विषय:- जनपद बागेश्वर के अन्तर्गत प्रधानमंत्री ग्राम सड़क योजना के अन्तर्गत गरूड़-निखोली से कोठों तक मोटर मार्ग के निर्माण हेतु 0.54 है० वन भूमि का गैर वानिकी कार्य हेतु ग्राम्य विकास विभाग को प्रत्यावर्तन। (FP/UK/ROAD/10272/2015)

विषय - जनपद बागेश्वर के अन्तर्गत प्रधानमंत्री ग्राम सड़क योजना के अन्तर्गत गरूड-बिनखोली से कोठों तक मोटर मार्ग के निर्माण हेतु 0.54 है० वन भूमि का गैर वानिकी कार्य हेतु ग्राम्य विकास विभाग को प्रत्यावर्तन के सम्बन्ध में (प्रस्ताव संख्या-10272/2015)

विषय:- जनपद बागेश्वर के अन्तर्गत प्रधानमंत्री ग्राम सड़क योजना के अन्तर्गत गरुड़-बिनखोली से कोठों तक मोटर मार्ग के निर्माण हेतु 0.54 है० वनभूमि का गैर वानिकी कार्य हेतु ग्राम्य विकास विभाग को प्रत्यावर्तन। (Online Proposal No- FP/UK/ROAD/10272/2015)।

डिजिटल मैप :- जिला बागेश्वर में प्रधानमंत्री ग्राम सड़क योजना के अन्तर्गत प्रस्तावित
 गरुड-बिनखोली से कोठो मोटर मार्ग (ल०-2.600 कि०मी०)

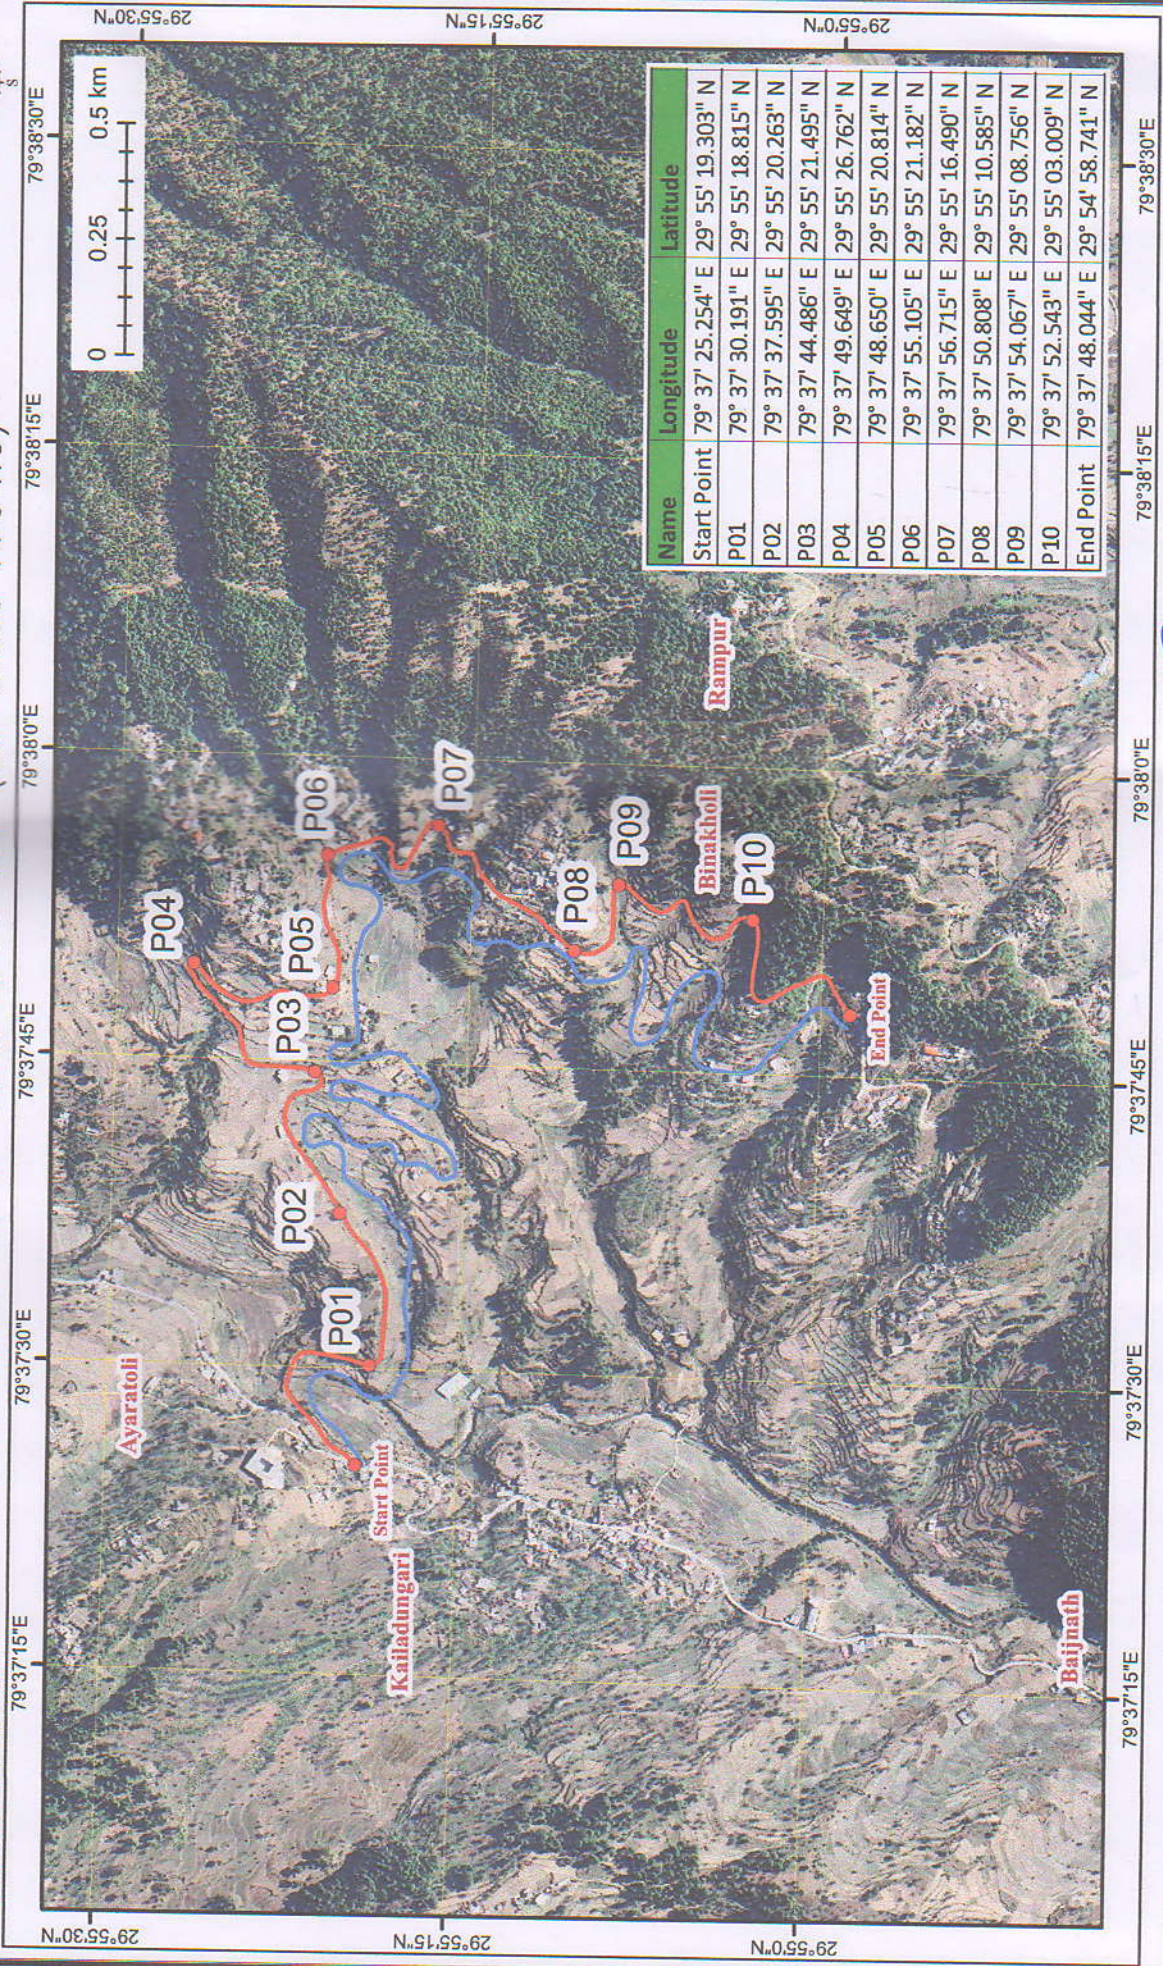
विन्दु स० 1	On perusal of the KML file it is observed that the alignment submitted in the form of KML file differs from the alignment on which actual work has been carried out further, it is observed that the digital geo-referenced maps of the area proposed road alignment is not marked on the toposheet as well.	The alignment submitted in the form of KML file is approximately same, only a bit difference is there in the nap land, due to the objections created by the villagers. There is no change in alignment in the forest area. The digital geo-reference maps of the area proposed to be diverted are uploaded in part-I and part-II and the proposed road alignment is marked on the toposheet. (Map attached)
2	Therefore, the State Govt. is requested to clarify if the road work was carried out on the area where demarcation and tree marking was carried out by the forest department. A certificate to this effect may be provided by the concerned DFO.	The road work in the forest area was carried out on the area where demarcation and the tree marking was carried out by the forest department.

3	If the road work has been carried out on the demarcated land then the reasons for incorrect KML may be provided. If not	The road work has been carried out in the demarcated forest land, and there is a bit

Sl. No	Shortcomings	Amendments
1	On perusal of the KML file it is observed that the alignment submitted in the form of KML file differs from the alignment on which actual work has been carried out. Further, it is observed that the digital geo-referenced maps of the area proposed road alignment is not marked on the topsheet as well.	The alignment submitted in the form of KML file is approximately same, only a bit difference is there in the Nap land, due to the objections created by the villagers. There is no change in alignment in the forest area. The digital geo-reference maps of the area proposed to be diverted are uploaded in Part I and Part II and the proposed road alignment is marked on the topsheet. (Map Attached)
2	Therefore, the State Govt. is requested to clarify if the road work was carried out on the area where demarcation and tree marking was carried out by the forest department. A certificate to this effect may be provided by the concerned DFO.	The road work in the forest area was carried out on the area where demarcation and the tree marking was carried out by the forest department.

detailed report on violation be submitted.	difference in the last portion nap land due to objections created by villagers in alignment.
4	The state Government is requested to provide the topo-sheet showing the proposed road and the geo-referenced map of the proposed road at appropriate places in part-I and part-II	The toposheet showing the proposed road and the geo referenced map attached. (Map attached)

3	If the road work has been carried out on the demarcated land then the reasons for incorrect KML may be provided. If not detailed report on violation be submitted.	The road works has been carried out in the demarcated forest land, and there is a bit difference in the last portion Nap land due to objections created by villagers in alignment.
4	The State Government is requested to provide the topo-sheet showing the proposed road and the geo-referenced map of the proposed road at appropriate places in Part I and Part-II	The toposheet showing the proposed road and the geo referenced map attached. (Map Attached)
